RECODE KNOXVILLE

Charrette Report

The East Tennessee Community Design Center appreciates the opportunity to develop this report on the findings from the Recode Knoxville Design Charrette and Design Standards Roundtable Discussion.

Fifth Avenue & Central Street

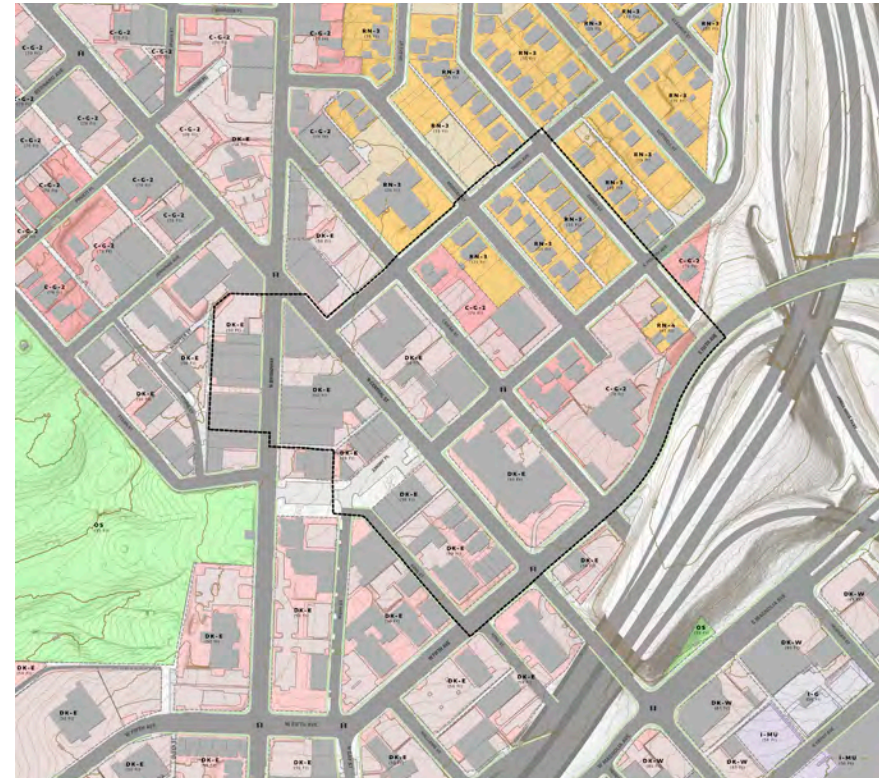
In their development of this site, Team 1 found that the newly created Downtown Edge (DK-E) zoning, which requires no off-street parking, was both helpful and restraining. They felt that it was particularly helpful in achieving the goal of added (and needed) density to land near downtown, whether in residential or commercial uses. However, they also felt that it would be harder to market to most local developers, as they would still bring with them the suburban, car-dominant mentality and would be uncomfortable, from a business-stance, developing a site without any parking. Though the team felt a large portion of needed parking could be attained from on-street parking, they acknowledged that this amount would be a large minority of parking at the most, especially if an intense retail site was to be developed here.

As well, the team found that the proposed zoning maps were severely lacking in well-placed transitions of zones from higher density and intensity to lower density and intensity. They felt that there needed to be more RN-4 zones to act as transitions from traditional RN-2 and RN-3 neighborhoods to the DK-E zones or other commercial zones such as C-G-2 and C-G-3.

- There needs to be a comprehensive plan (and perhaps a map overlay zone) that indicates structures or areas that the city would like to consider historic and would preferably renovate as opposed to destroy.
- There is potential for another overlay zone that deals with sites that could possibly be transit-oriented developments; such overlay zones would allow for special reductions in parking.

Bearden at Homberg

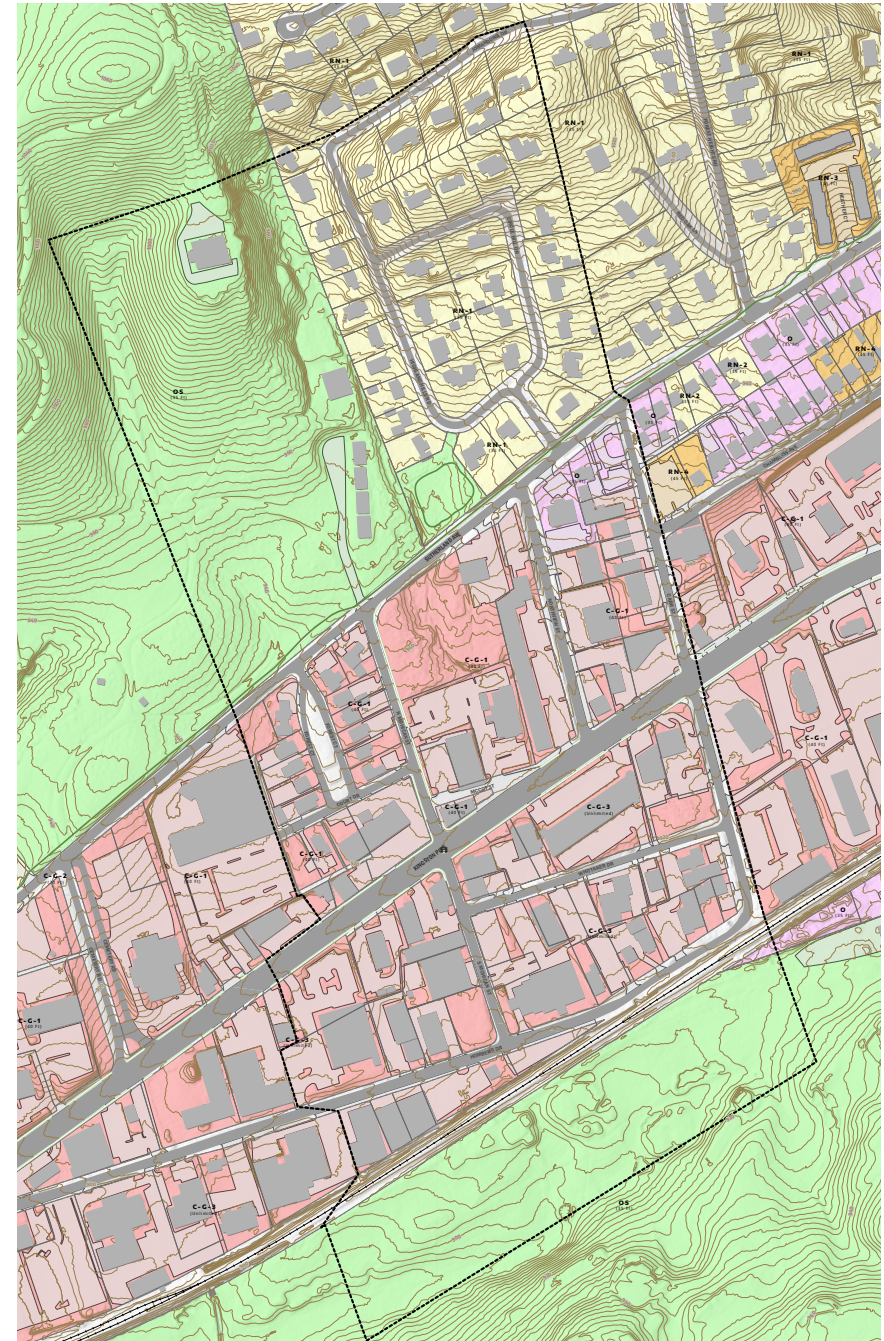
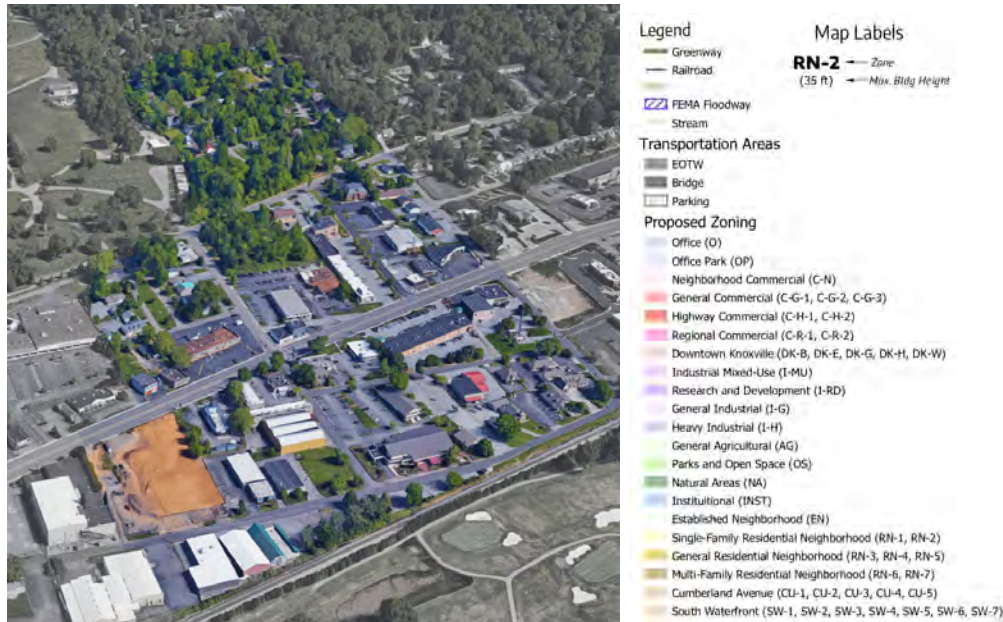
In looking at this portion of Kingston Pike, Team 2 found that the proposed zoning is very conducive to creating the desired transition of zones from lower to higher intensities. On the northern side of Kingston Pike, below the single-family residential areas, the team proposed to have street-facing, mixed-use developments of two and three stories, with parking in the center of the block. Allowing for a minor change in the proposed zoning, the team was able to design a small pocket neighborhood to the northeast of these. Across the street, the zoning becomes C-G-3, which allows for unlimited height. This allowed the team to transition further to more intense developments of four, six, and ten story buildings as they moved closer to the railroad tracks at the southern end of the site. The team discussed the validity of a ten story building in this portion of town by noting that the building would not only act as a buffer between the trains and the rest of the corridor on the block, but that as the buildings stepped down in height gradually as they went north, the scale would not be overwhelming or feel out of place.

The team also created on-street parking along Kingston Pike in an effort to make it more of a safe pedestrian street and less of a 'stroad'. They incorporated multi-family housing on adjacent blocks as well to help with the building scale transitions and sense of walkability. Parking was buried for the major development on the southern block. The team noted that with the proposed parking minimums, the associated costs for buried or structured parking would be something that would need to be prepared for if we want to move away from giant surface lots, even if those lots are hidden in the middle of a block.

The team felt that this site was generally well-suited for the goals of Recode in terms of creating higher densities, more walkability, and better zone transitions. However, the team also felt that parking requirements were still a major impediment, and that landscaping requirements, though clear for residential and residential-adjacent zones, needed to be written more clearly when regarding sole-commercial zones.

Parkridge at First Creek

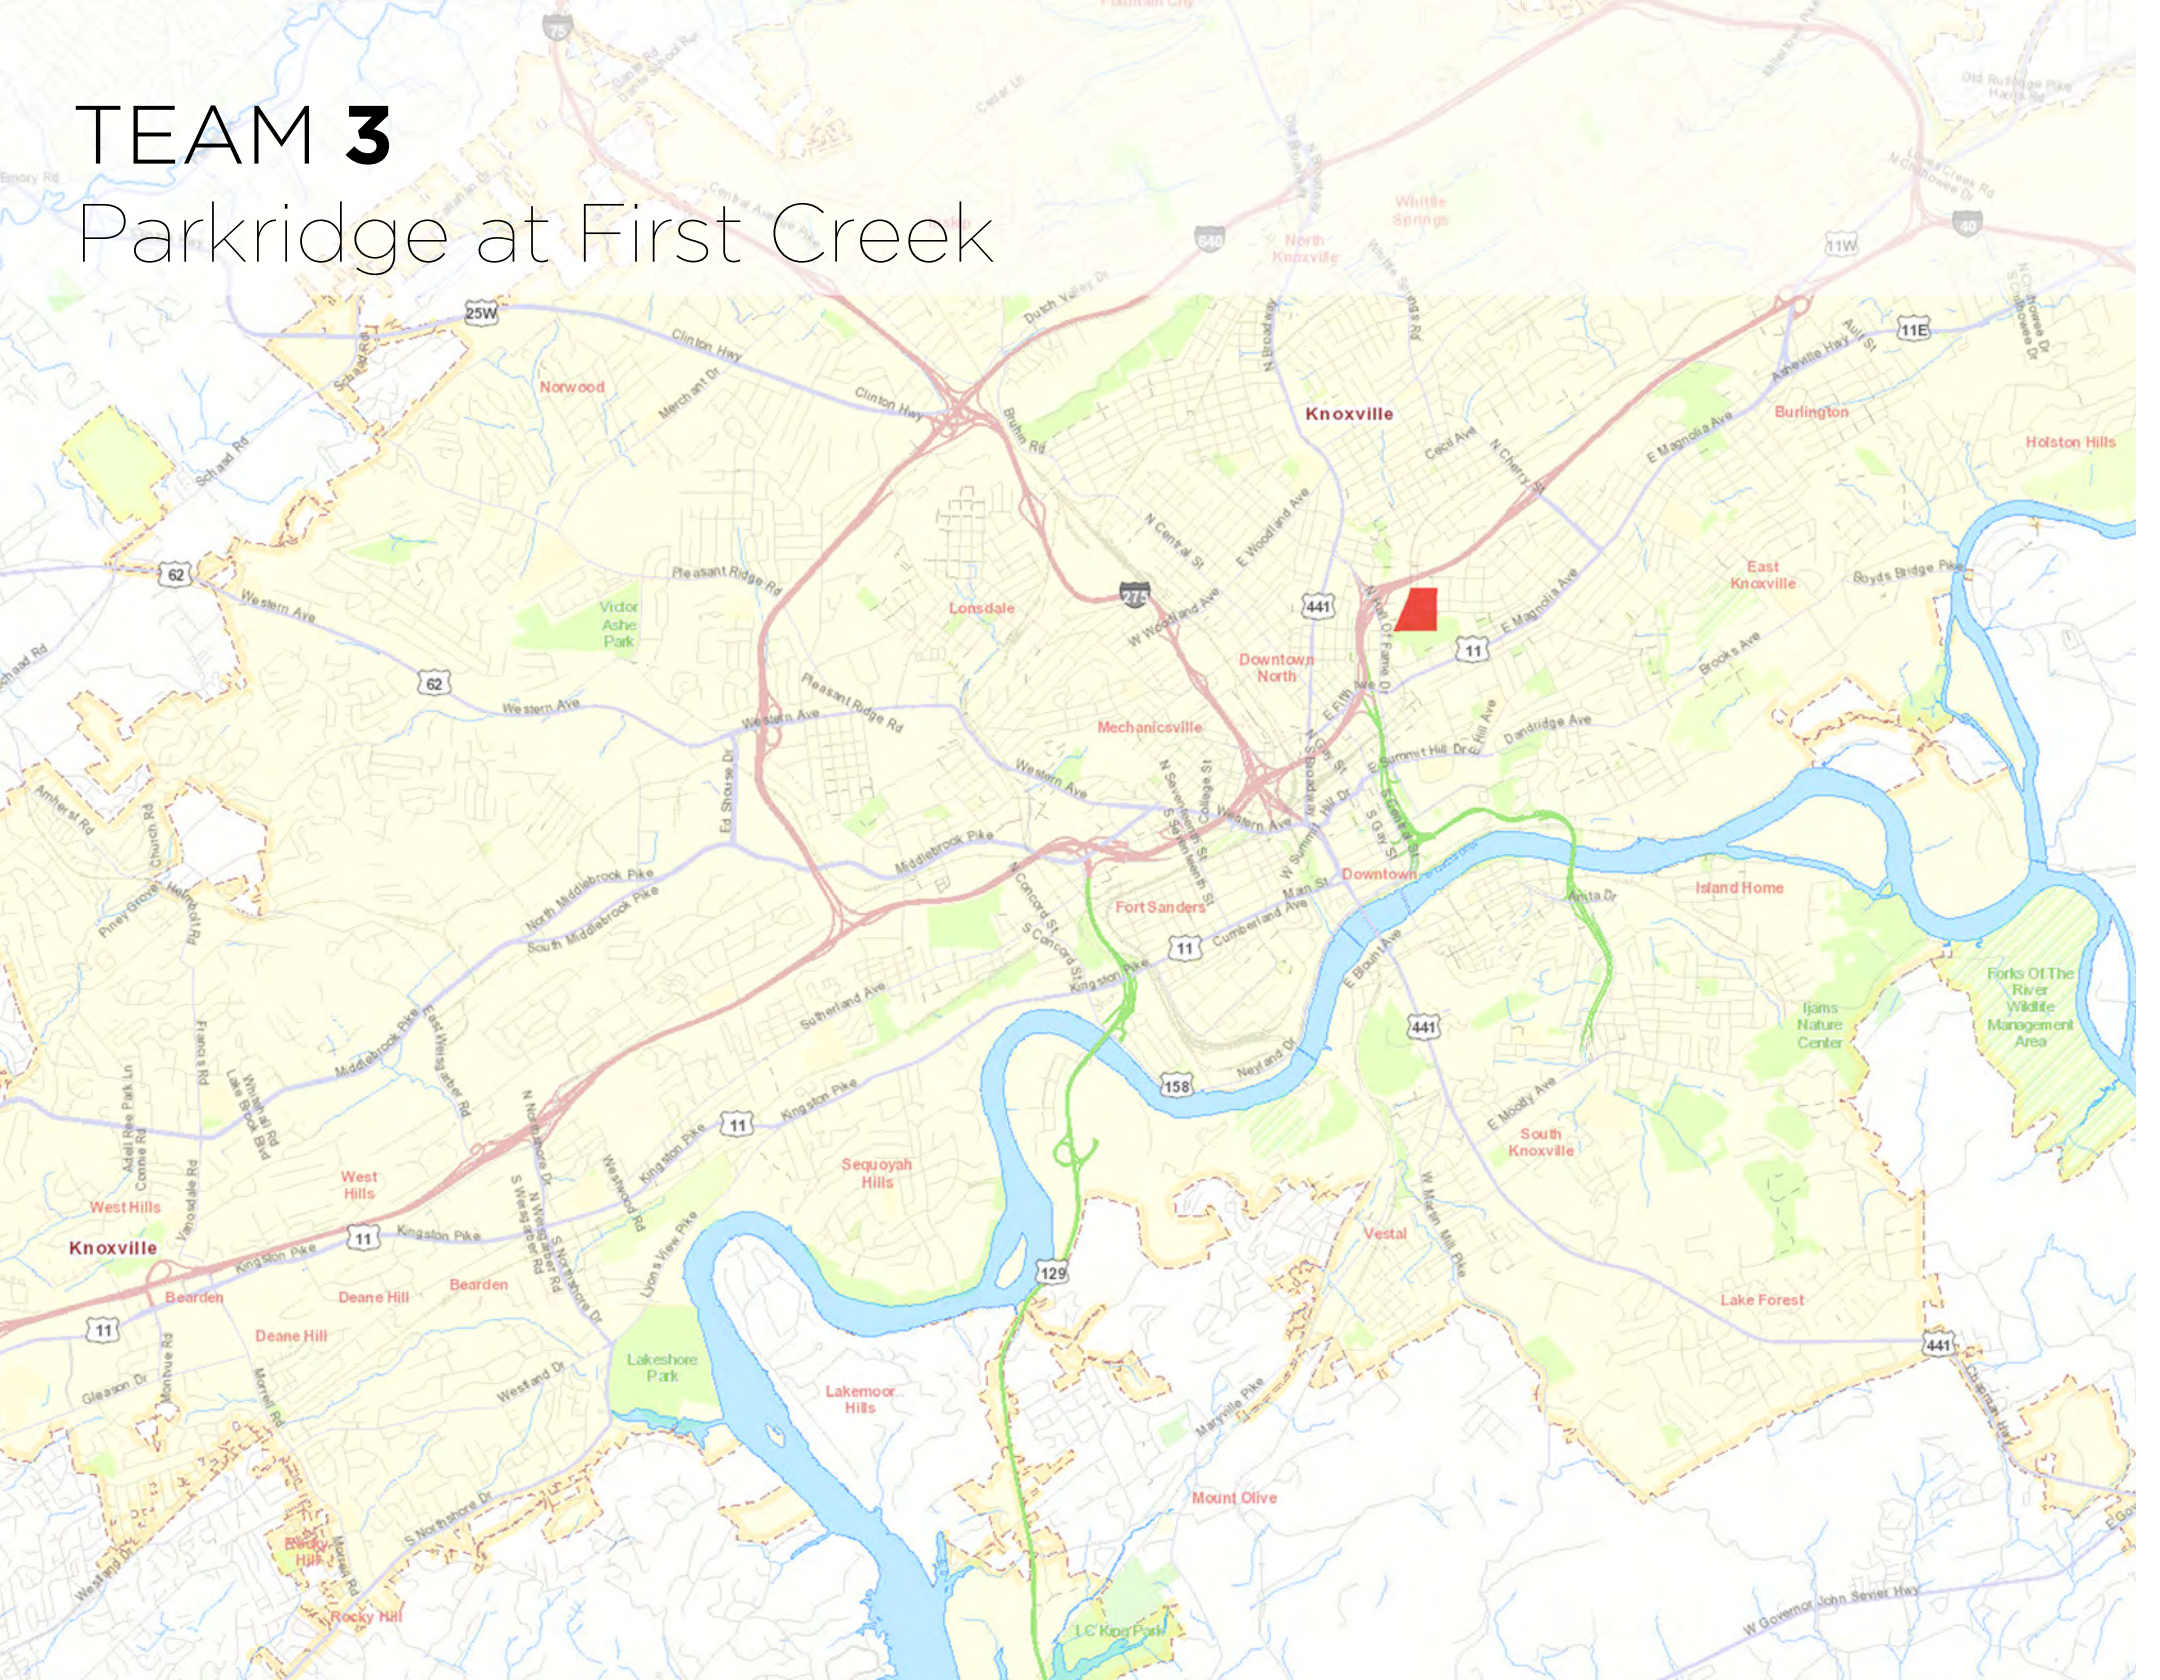
In their attempts to save the historic Standard Knitting Mill, Team 3 felt that for a feasible and realistic proposal to do well with the given parking requirements outlined in the new code, a portion of the Mill would have to be demolished or converted into structured parking. This brought up the idea once more of an overlay for potential or preferred transit-oriented development sites, which would allow for a reduction in parking. This would be different than the reduction allowed in the proposed code, which only applies to existing transit-stops near a site.

The team realized that the Mill needed a road frontage and thus added a new road connecting north into historic Parkridge, west to Hall of Fame Drive, and south into Caswell Park. Multiple office buildings were added along this road frontage near the Mill to help hide parking from view. As well, an urban agricultural zone (perhaps a relocated Abbey Fields or another community garden) was placed alongside First Creek.

The team felt that the current continuation of the industrial zone behind some residences was antiquated and unnecessary. They suggested that it should be changed to a higher-intensity residential, such as R-4, to allow for a better transition from the neighborhood homes to the proposed office and mixed use developments on the historic commercial street.

A question that was raised during the exploration of this site was whether residences or other zones could create or use shared parking with a playground or park space, such as the one adjacent to the Mill and neighborhood. A critique was also mentioned that addressed whether sites like this one, which are near a major interstate and are close to other large buildings (and therefore somewhat 'hidden'), should have special allowances for height, as opposed to the current zones, which are largely based upon existing and adjacent zones.
